**Re: Notice of Potential Component Issue – 002.**

<h1>OTIS</h1>	<h2>Notice of Potential Component Issue</h2>	<b>Ref : 002</b> (CI45-12-G03)	
		<b>Page : 1/3</b>	
	<h3>Manual Recovery Operation wiring examination</h3>		ISSUE 05/01/2012

A potential production wiring error in the Manual Recovery Operation (MRO) circuit.

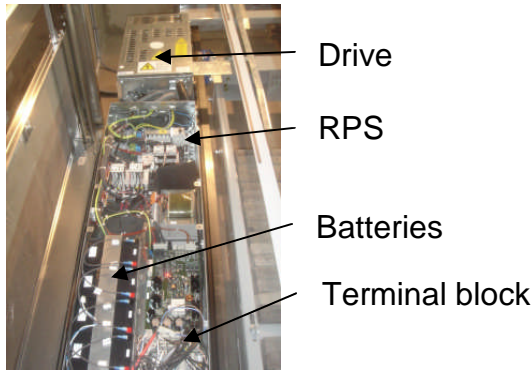
If the values are as below (same voltage values measured on the 3 points), this means that the wiring is NOT correct. THE MRO MUST NOT BE USED AND THE FAULT RECTIFIED.

P6.1/Gnd	(48 to 55 VDC) or 0 V
P6.2/Gnd	48 to 55 VDC
P6.3/Gnd	48 to 55 VDC

If the examination results indicate the wiring connections are **incorrect** then follow the further field solution directions steps 1-22 on pages two and three. Until this solution has been completed the **MRO** function must not be used.

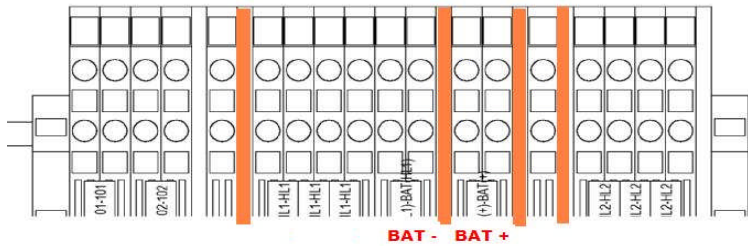
3. On the terminals located in the bottom of the PSRB/PSRBD, identify **BAT+** and **BAT-**

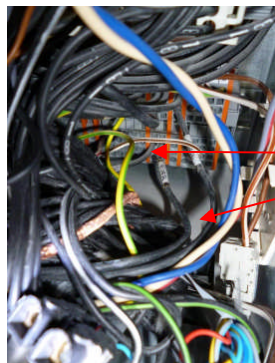
**Wires TB2-BAT(-) and TB2-BAT(+) incorrectly connected together on BAT(+) terminals.**

5. Disconnect **TB2-BAT(-)** wire from the terminal and check that this wire is the one connected to the **P6.3** in the E&I panel. This should be checked by using the multimeter (continuity test) and a test lead of suitable length.

6. Reconnect this **TB2-BAT(-) wire** in the correct terminal **BAT(-)**.
7. Switch **ON** RPS inside the PSRB/PSRBD and close the PBSB/PSRBD.
8. Egress from the car top.
